FARR WEST CITY COUNCIL AGENDA

RE: **MONTANO SUBDIVISION & SITE PLAN (Willard Bay Ph 2 Subdivision 1st Amendment)
Final Improvement Drawings**

PLAN REVIEW

FIRE MARSHAL PLAN FOR
MONTANO
3770 & 3762 N. HIGLEY ROAD
FARR WEST, UTAH 84404
A Part of the Southeast Quarter of Section 2
Township 10 North, Range 2 West, S.L.B.&M.

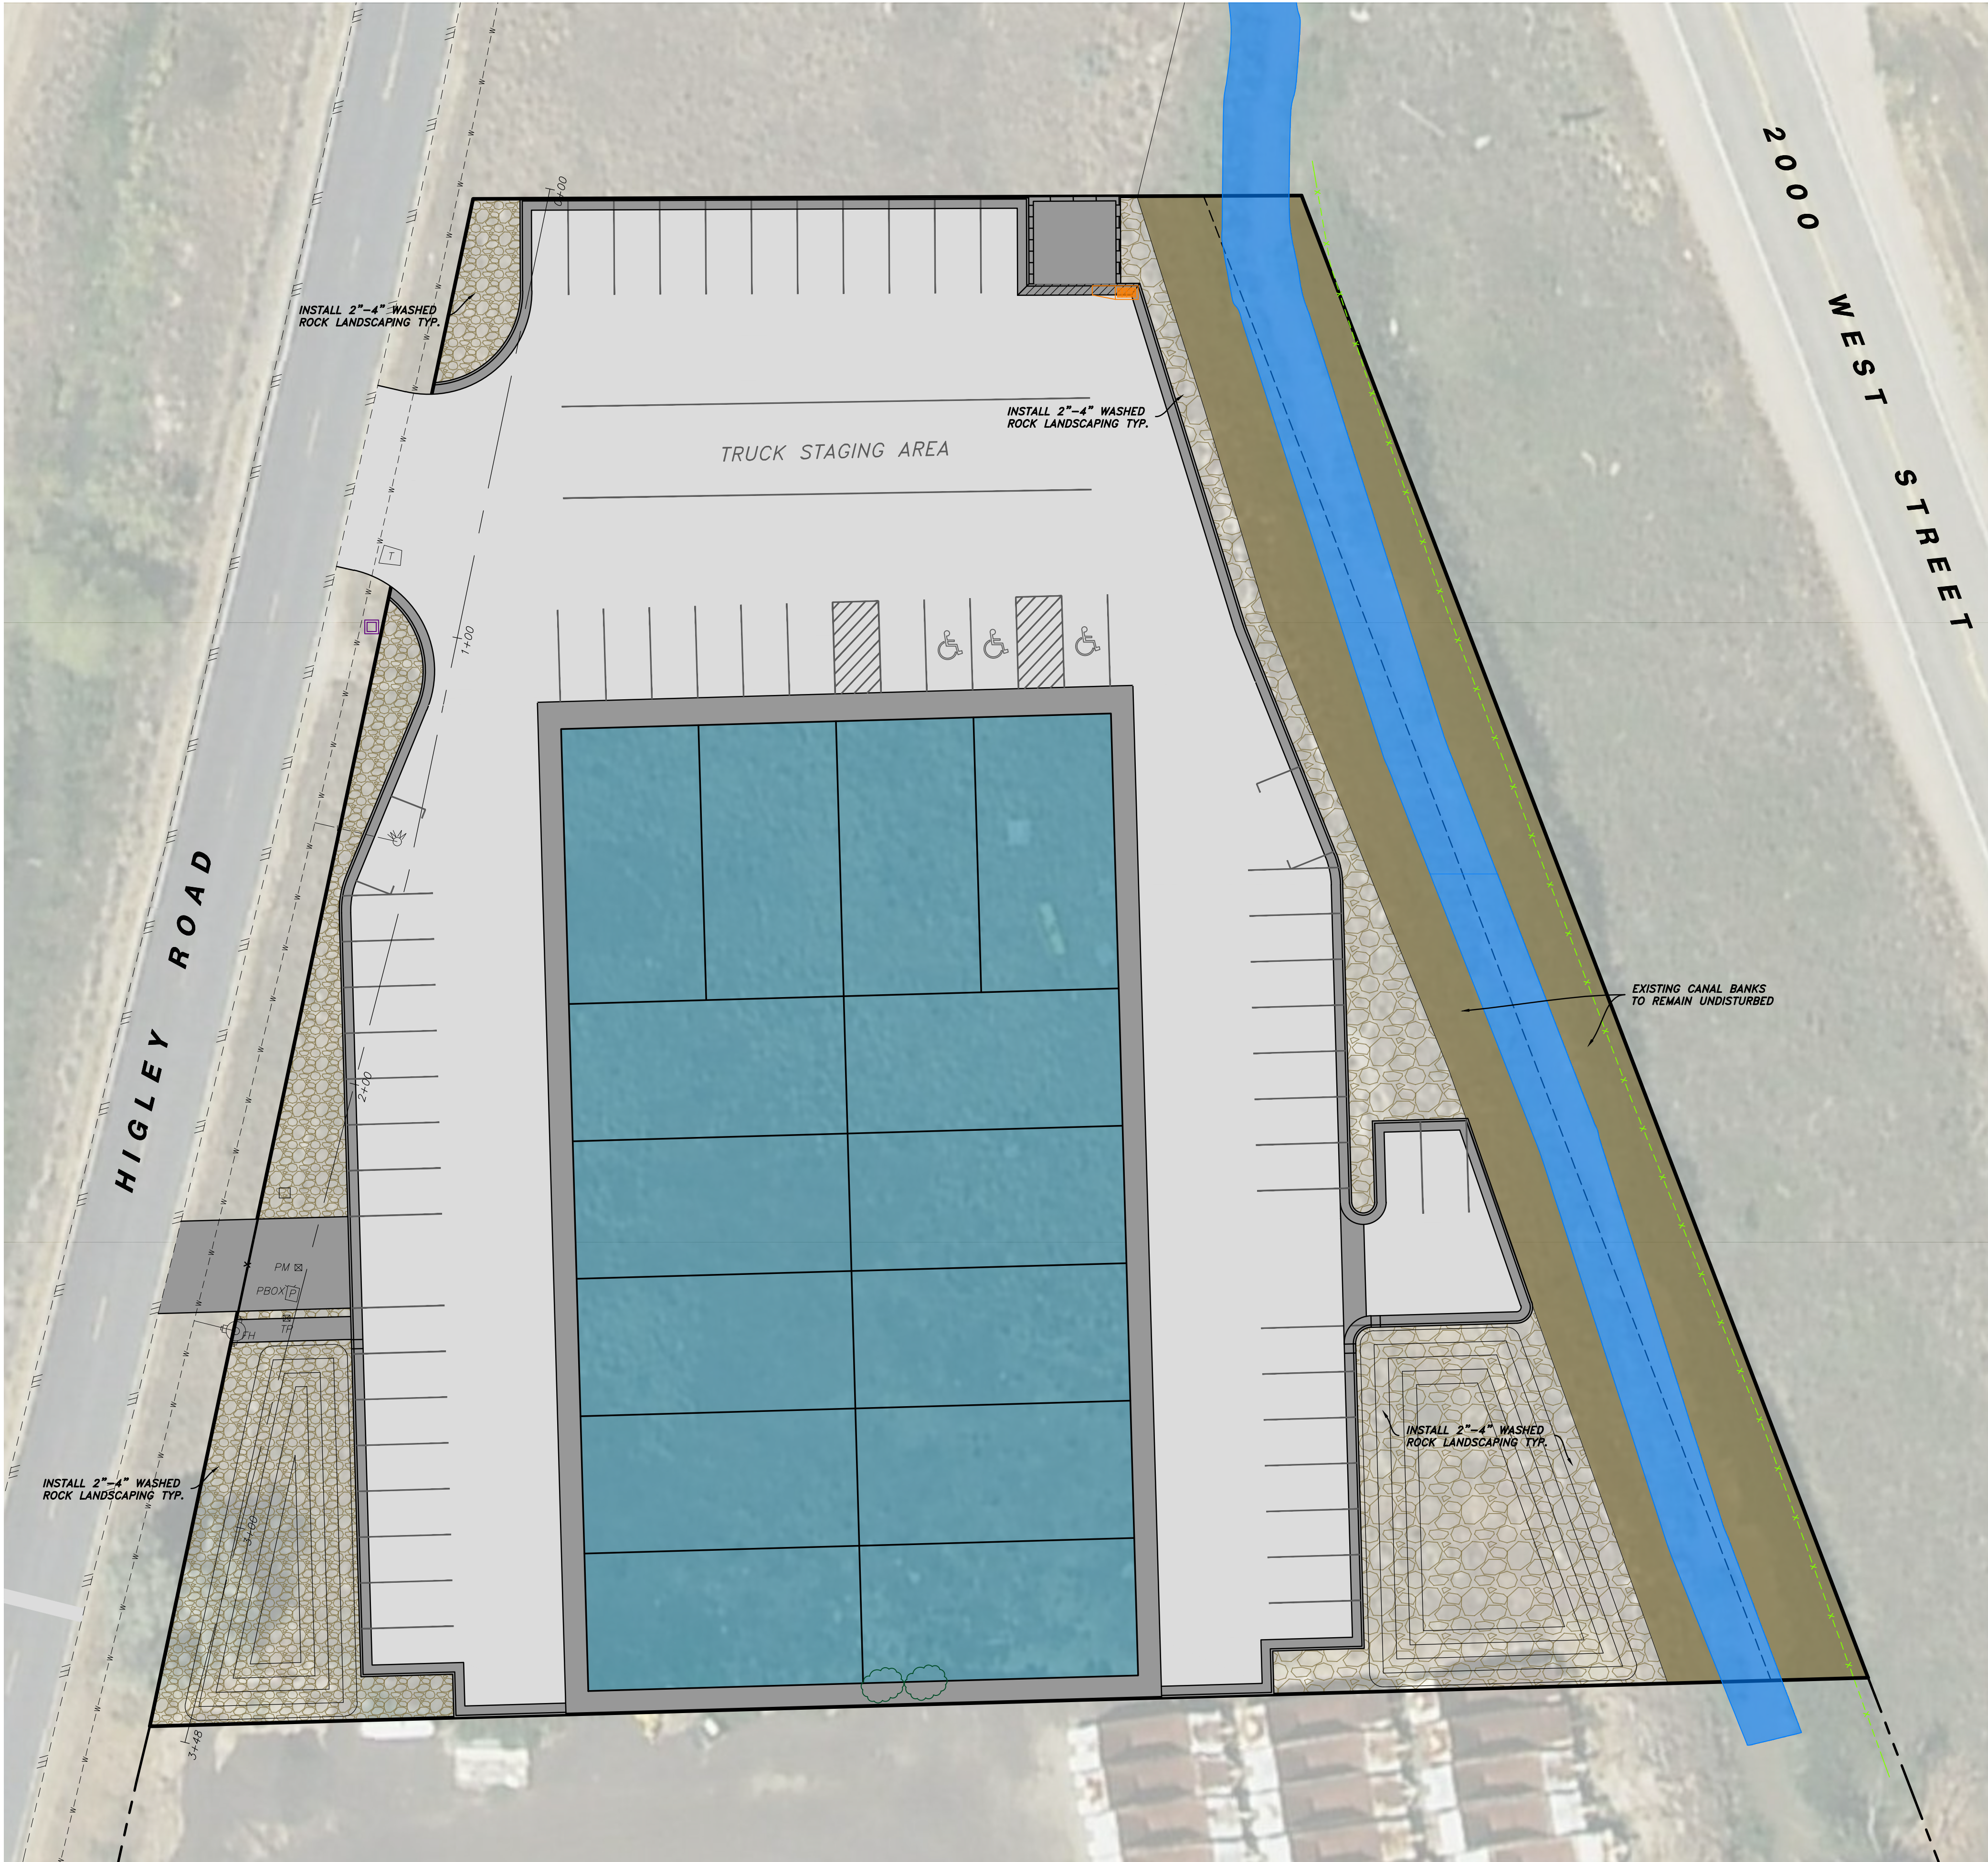
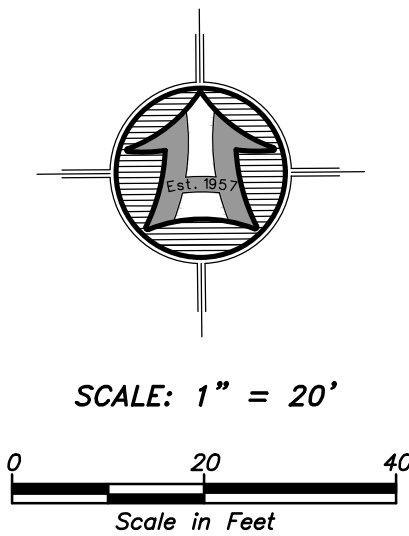
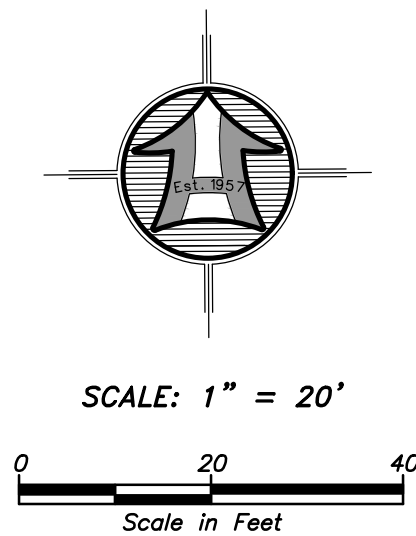
- d. If deficiency exists, proposed method to obtain conformance with adopted codes and Resolution 04-2014.
- S2. Fire Flow: The required fire flow for this building is based upon the construction type and the square footage. The fire flow shall be 1500 GPM for 2 Hours. Additional hydrants may be required to meet fire flow requirement. (See IFC Appendix B, B105.1(2)).
- S3. Fire Flow Reduction: A 75% reduction in fire flow has been granted for this project due to the building being equipped with a fire suppression system.
- S4. Fire Hydrant(s): As per approved plans.
- S5. All required fire hydrants and water systems shall be installed, approved and fully functional and on, prior to any combustible construction (IFC section 507.1 and 3312).

G4. Roundabouts: Roundabouts in roadways shall maintain the required minimum width of 20 feet. Wider roadways may be required to provide turning radius for fire apparatus. An auto-turn model shall be completed and submitted for review. The following vehicle information shall be used for this purpose:

G8. All roads shall be designed, constructed, surfaced, and maintained to provide an all-weather driving surface. All weather surfaces may include road-base material however, the roadway must be maintained open and accessible year-round (See IFC section 503.2.3 and D102.1).
